Appendix B: Public Consultation Submission Report – 1st Non-Statutory Public Consultation

BusConnects Dublin Core Bus Corridor Projects

Corridor 1 – Clongriffin to City Centre

Emerging Preferred Route – Public Consultation Report 2018/2019

Section 1: Clongriffin DART Station

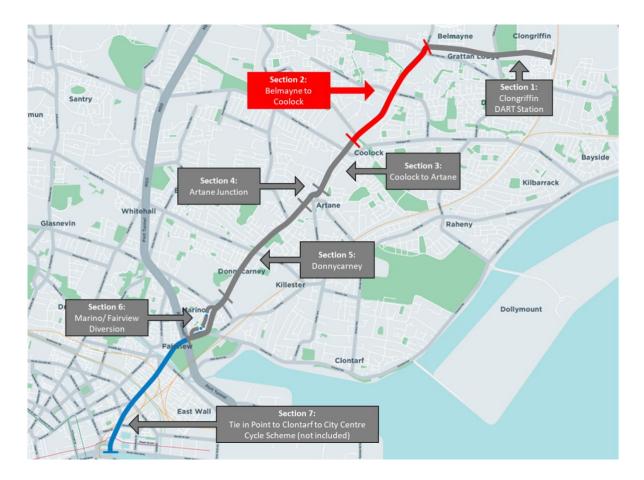
The provision of cycle facilities should be implemented to encourage mode share.

Absolutely no provision for cyclists here.

Main street/Park Avenue Junction: cycle lane stops, and cyclists are encouraged to use bus lane. At present they mount the footpath and will continue to do so which is not safe.

Box/pocket turns for cyclists should be provided on all sides of the junction.

Cycle lane disappears on this map, provision for parking inside the bus lane and where cyclists will be travelling; Potential hazards.

Right hand turns for vehicles should be removed on minor roads.

MAP 4: Submissions fear that cyclists will cycle through pelican crossings. No cycle facilities.

MAP 5: No cycle facilities.

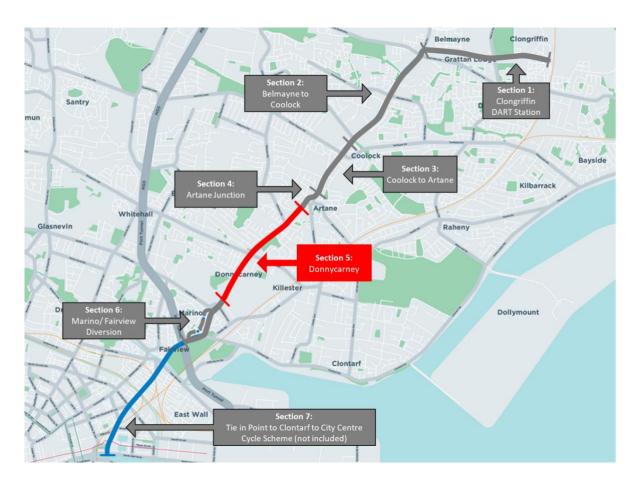
Sufficient space here to provide a verge between the cycle and bus lane and make the cycle lane wider.

Plenty of space to provide a Dutch Style Junction and segregation facilities for vehicles, pedestrians, buses and cyclists.

Remove left slip lane.

Provide verge between cycle lanes and bus lanes instead of in the middle of the road to increase attractiveness to less experienced cyclists.

The former Crown Paints' main distribution centre for Ireland is at 1-3 Malahide Road. Existing road layout is designed to physically restrict right-out movements from the site onto Malahide Road. The proposed layout on Map 10 is not as restrictive as the existing layout, vehicles attempting to make this right turn manoeuvre could represent both a risk to traffic safety on Malahide Road, and also result in blocking back of traffic into the site / along Malahide Road. The site entrance should provide for Heavy Goods Vehicles as the future of this warehouse is unknown.

Need to provide a continuous cycle lane here.

Junction should be redesigned to better provide for cyclists with segregated cycle facilities. Access to Mount Dillon Court from Malahide Road is not currently possible

Cycle lanes should cross side streets and minor roads via a raised table.

Danieli Road is currently exit only, but is proposed 2 way?
